ADDENDUM

PROJECT: Waverly Lawson Park
Phase II Improvements
Waverly, Nebraska

AD-1

DATE ISSUED: Wednesday, September 10, 2014

From Sheet A-302M	for CA use:
Drawing # A-302M.1

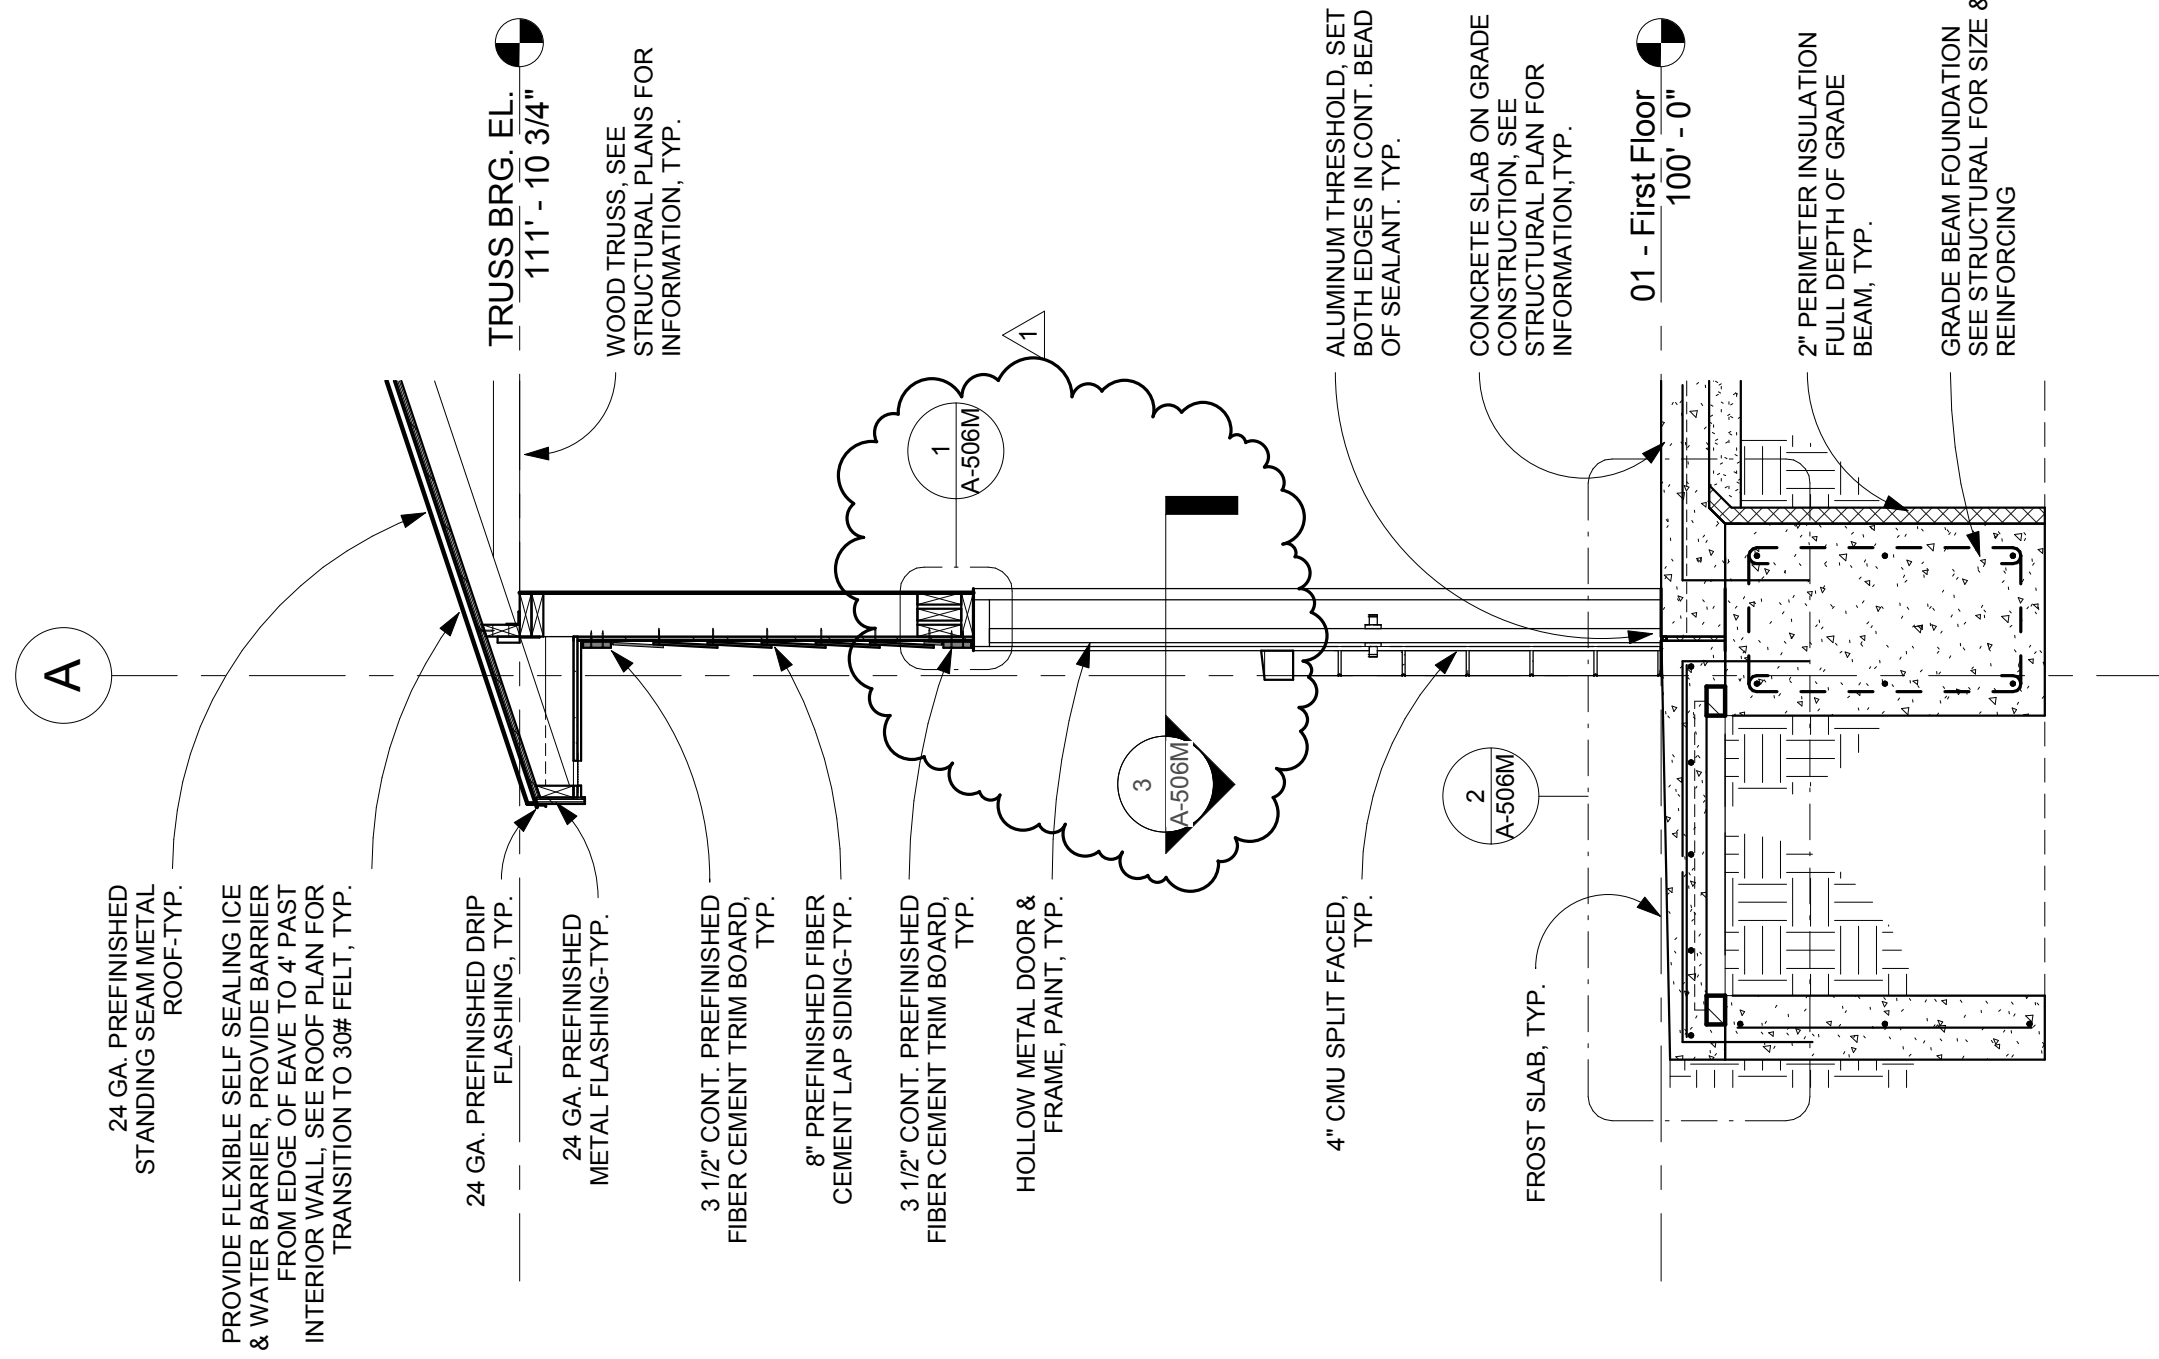
In reference to Sheet A-302M - Building Sections, revisions have been made to wall section 6. See clouded area on attached Supplemental Drawing A-302M.1.

SHEET NUMBER
A-405C

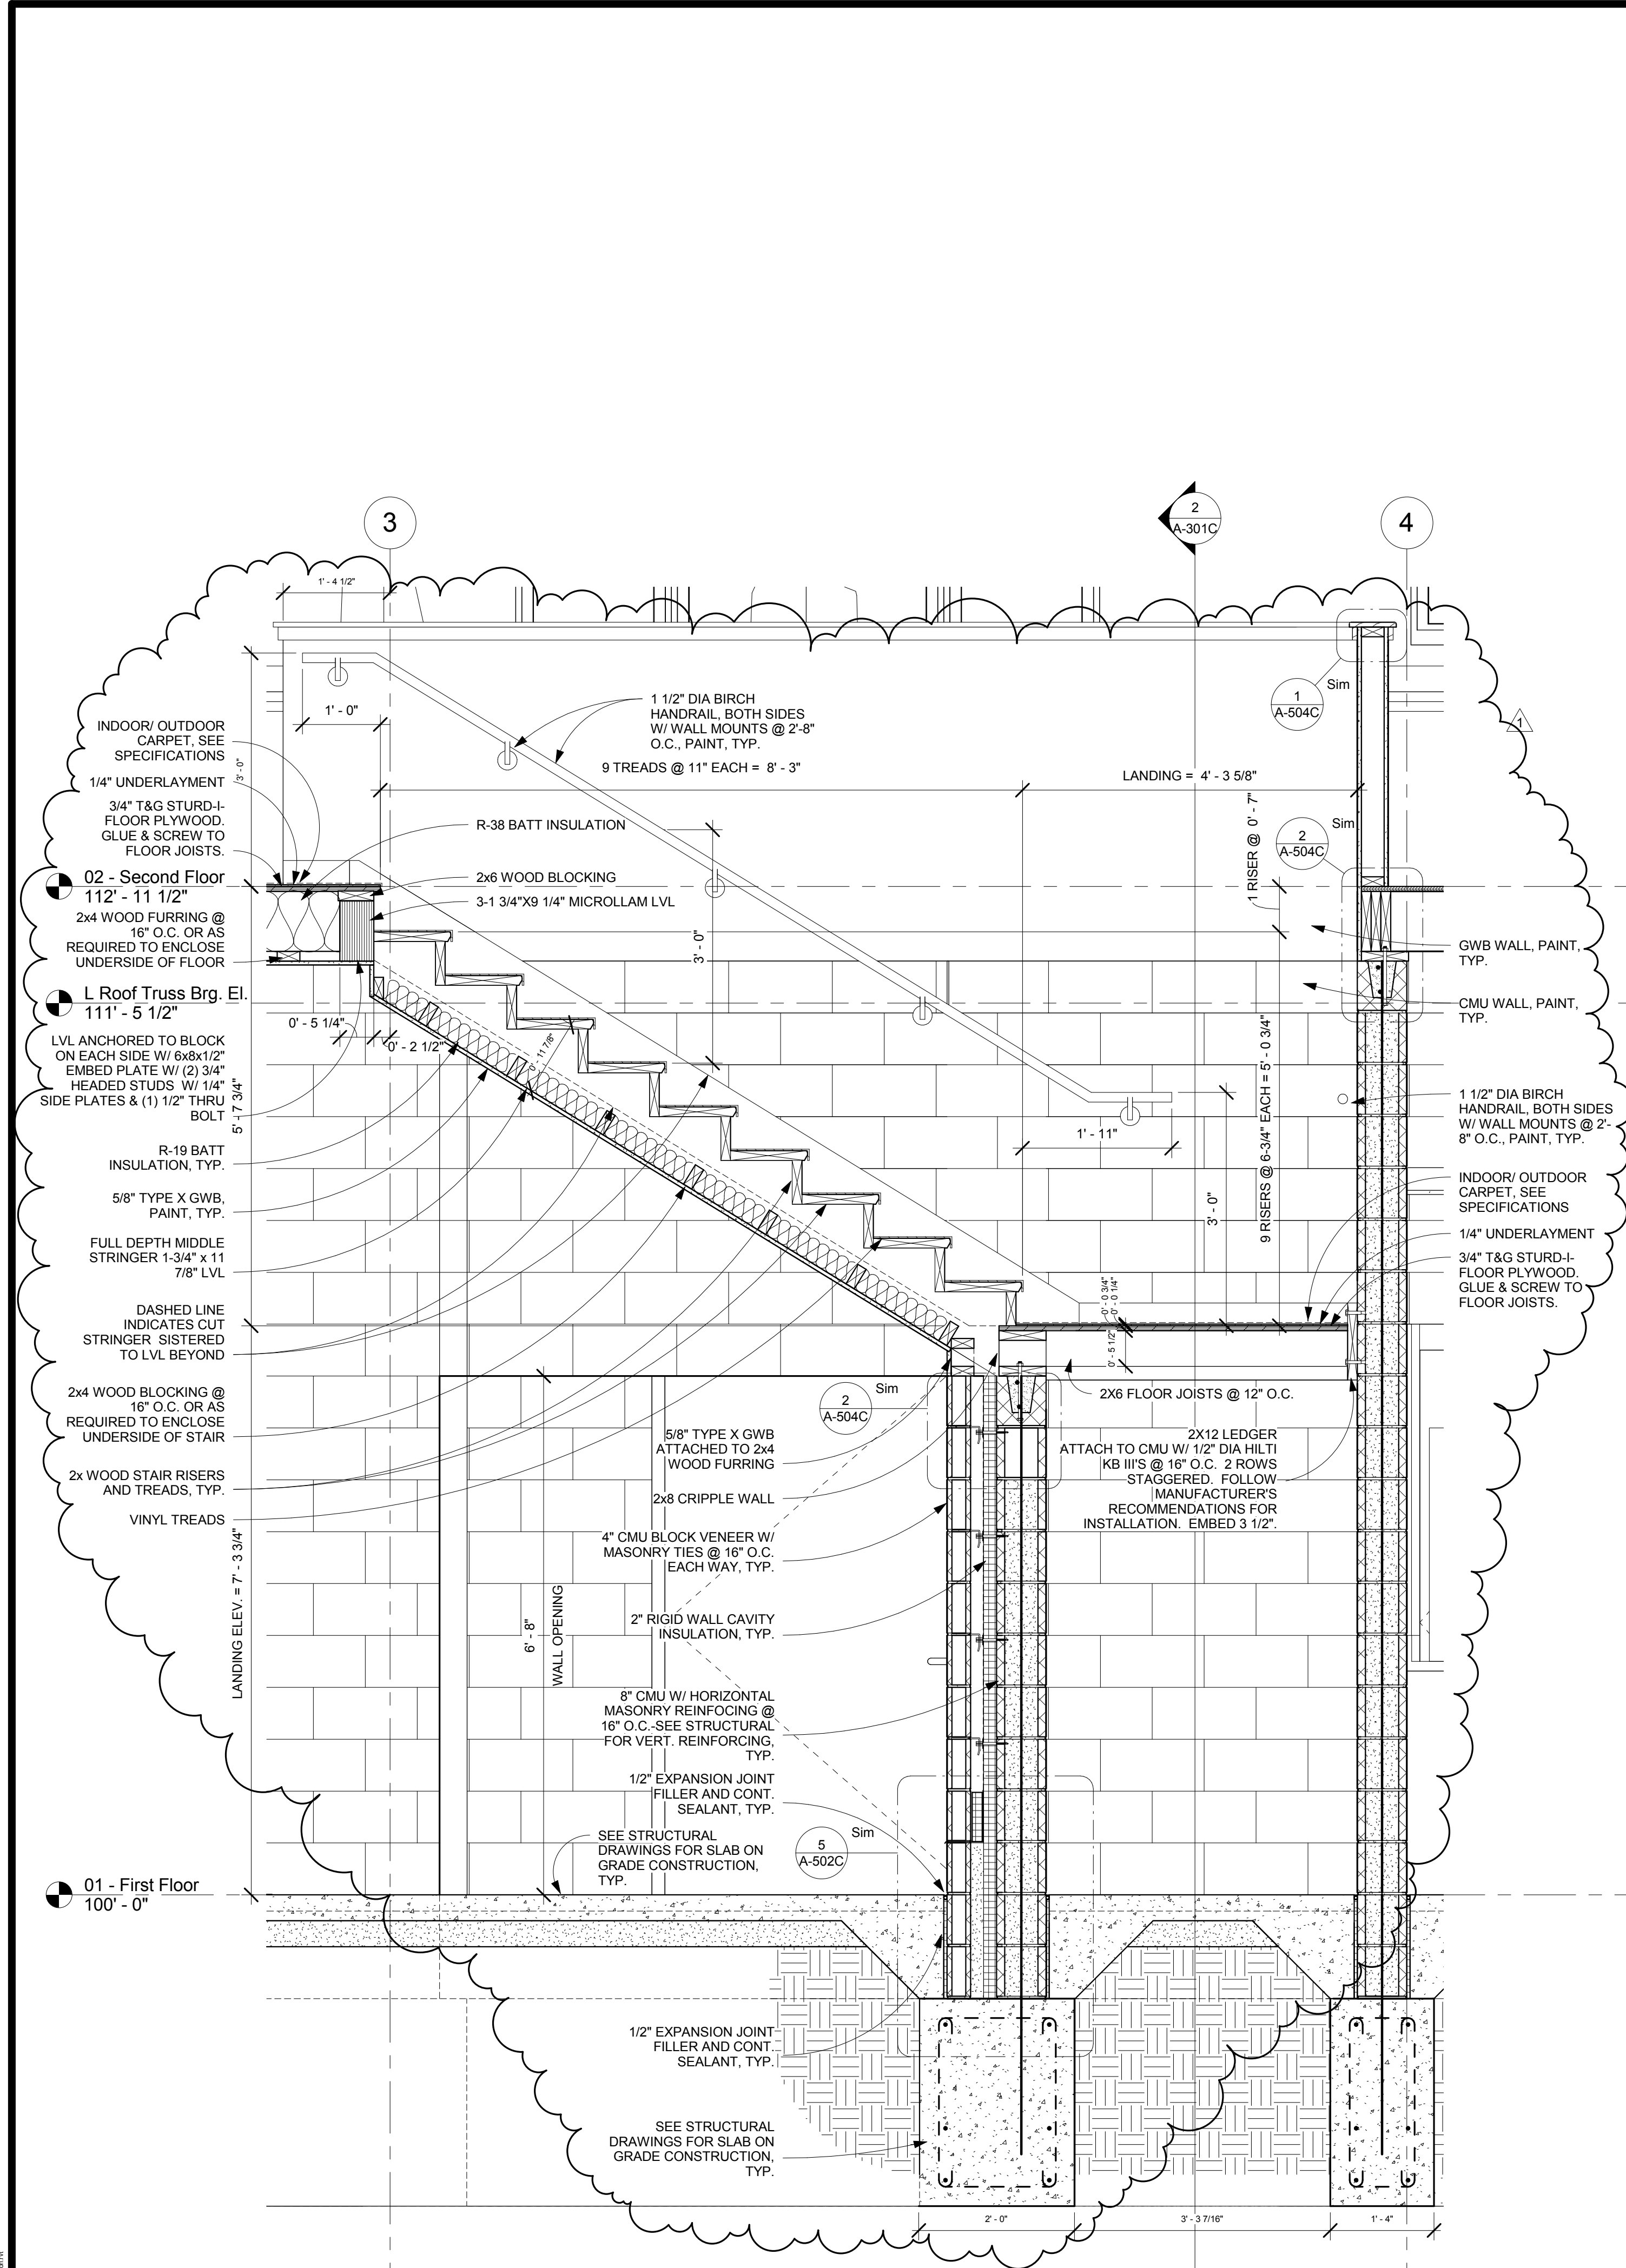
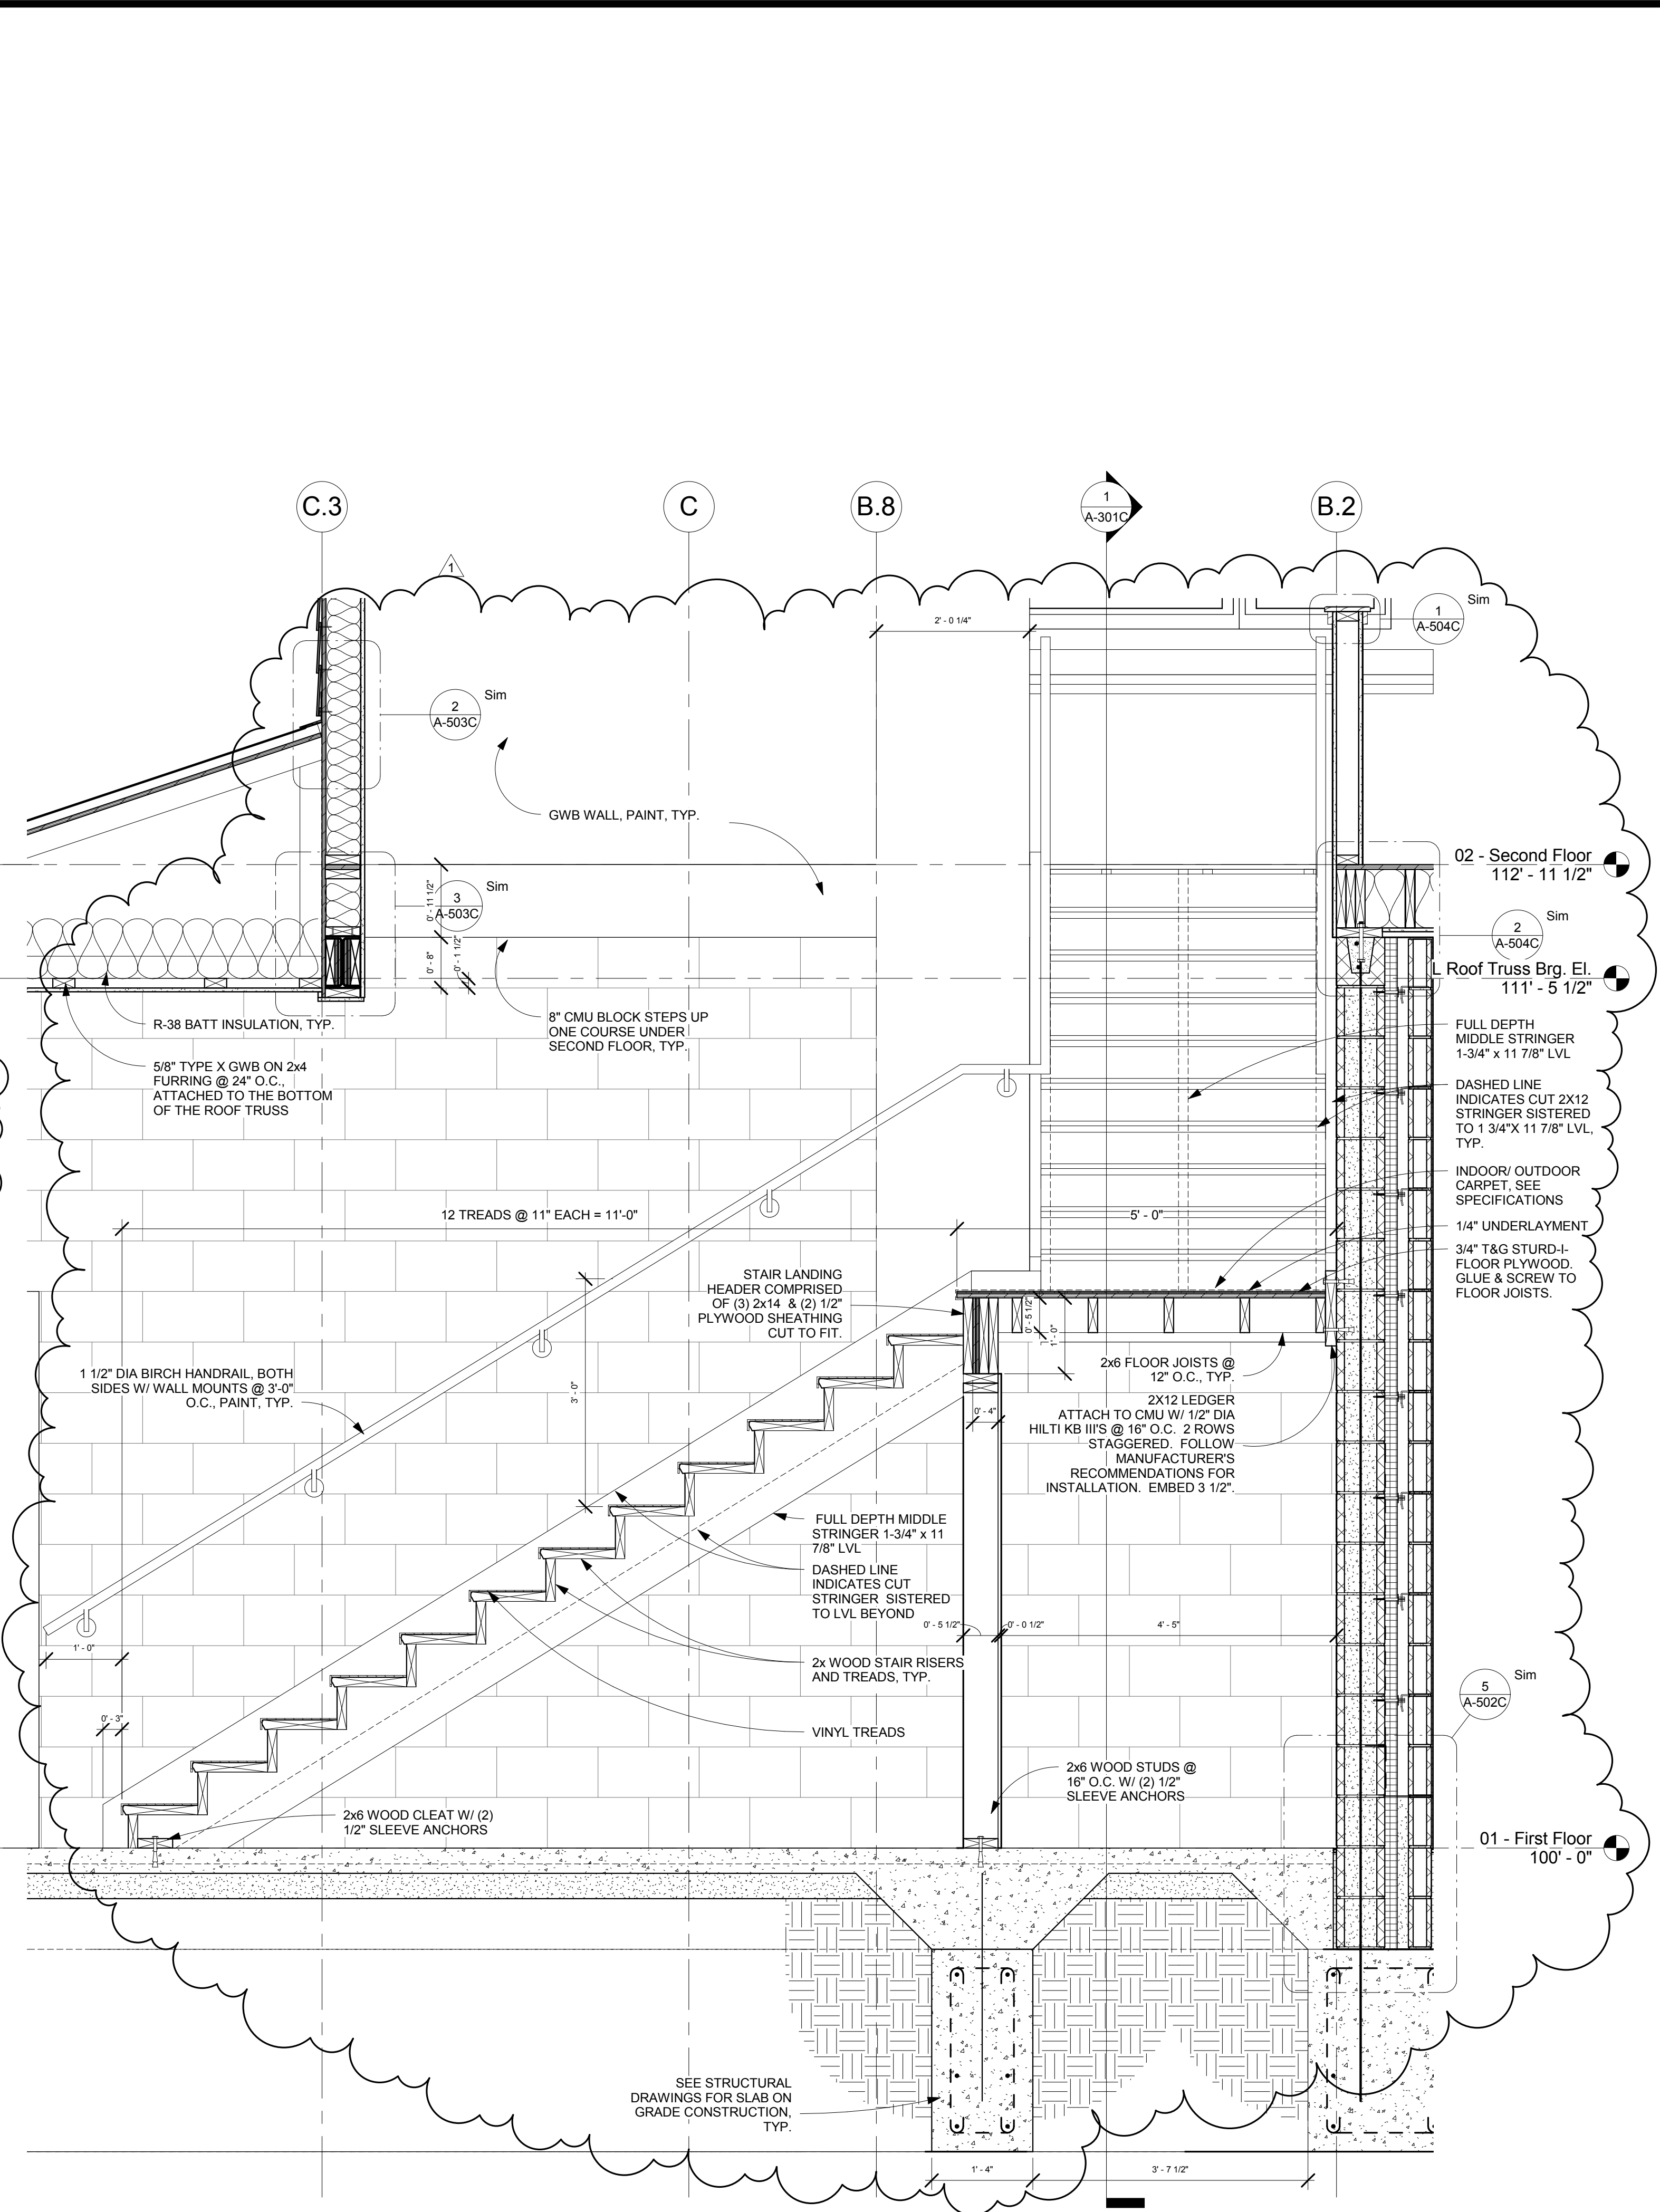
In reference to Sheet A-405C - Stair/ Wall Sections, stair section 1 & 2 were revised. See clouded area on attached Supplemental Drawing A-405C.
